Clinton Power Station

Subject: Additional Information Supporting the License Amendment Request to Permit
Up rated Power Operation at Clinton Power Station

Additional Information Supporting the License Amendment Request to Permit Upgraded Power Operation at Clinton Power Station

Figure 4.2-1 Simplified VC Diagram - A Train "Hi Rad"

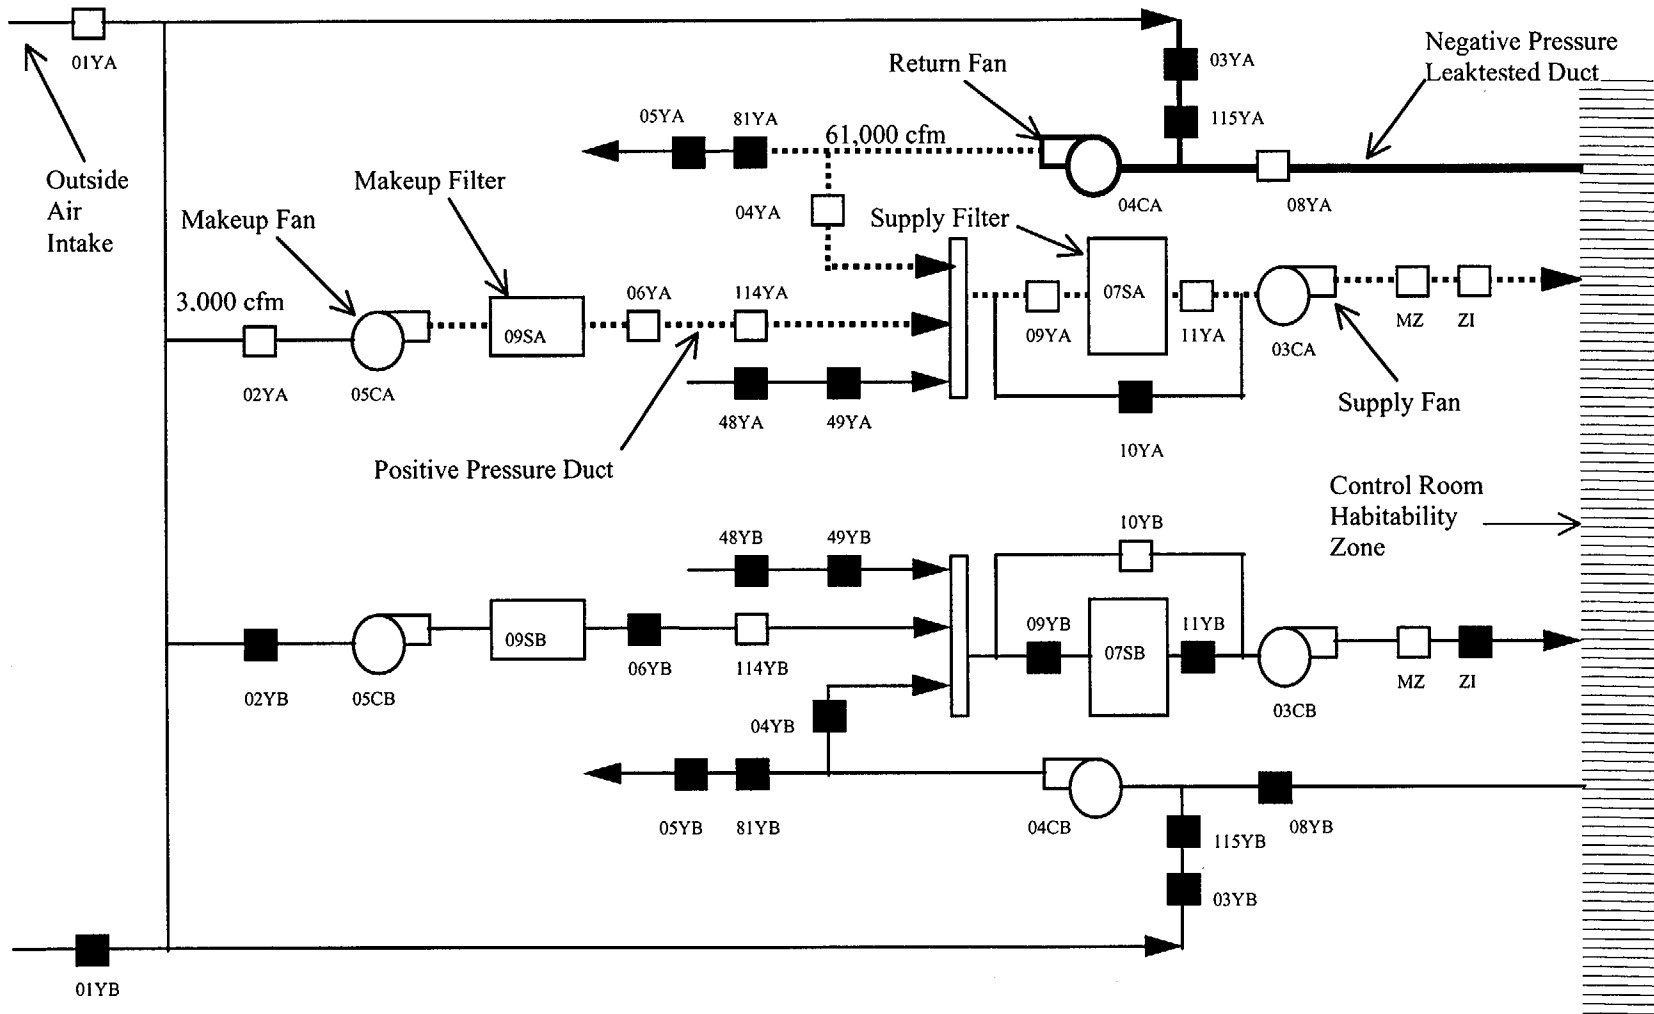
The staff has reviewed Amergen's response dated October 17, 2001 to its request for additional information. Question 4.2e requested: "Please provide a justification for control room unfiltered inleakage assumptions that have not been substantiated by appropriate integrated boundary leakage testing." Based on the information provided, the staff finds the Amergen response to be insufficient. Amergen is requested to supplement its response to RAI Question 4.2e with the requested justification of the CRS unfiltered inleakage assumption.

Several power reactors (representing over 20% of the U.S. plants, including those with filtered zone isolation and pressurization) have performed integrated testing of their control room inleakage, and in all but one case, the test results showed inleakage in excess of the facility's design basis. Based on this experience, concluding that the positive pressurization surveillance tests would result in no unfiltered inleakage (other than access doorways) during an accident condition is questionable. Given Amergen's projected post-EPU dose for the control room of 29 rem out of an allowable 30 rem, a increase in unfiltered inleakage could result in doses exceeding GDC-19.

The sources of contaminated air used in the dose assessment are based on the design of the CRVS, which utilizes zone isolation with filtered recirculation and zone pressurization. A simplified diagram of the system is shown in Figure 4.2-1. The system consists of two independent trains composed of a supply fan, a return fan, a makeup fan, a supply air filter package and a makeup air filter package. Each train is capable of

providing 100% of the required air flow, so only one train is normally operating. When the High Radiation (i.e., "Hi Rad") mode of operation is initiated by high radiation readings in the intake duct, the makeup fan in the operating train, which is normally not running, is automatically started. A nominal makeup flow of 3,000 cfm is passed through the makeup filter unit, which contains a 99% efficient charcoal filter for iodine removal. The return fan continues to operate at a nominal flow rate of 61,000 cfm from the control room. The return, or recirculation, flow is combined with the makeup flow and is passed through the supply filter before being supplied to the control room. The supply filter unit contains a 70% efficient charcoal filter for iodine removal.

A significant portion of the ductwork and equipment in the CRVS is located outside the control room habitability zone. Ductwork outside the control room is a potential pathway for inleakage of unfiltered and potentially contaminated outside air if the ductwork is at negative pressure relative to the outside atmosphere. The only portion of the system that is at negative pressure during the "Hi Rad" mode of operation is the ductwork upstream of the return fan. Technical Specifications (TS) assure that the actual inleakage into this ductwork is less than the value used in the dose assessment. Any leakage into this ductwork passes through the supply filter, so this is considered filtered inleakage. The design of the system is such that the remainder of the ductwork downstream of the charcoal filters is maintained at positive pressure, which precludes the infiltration of additional outside air into the CRVS.
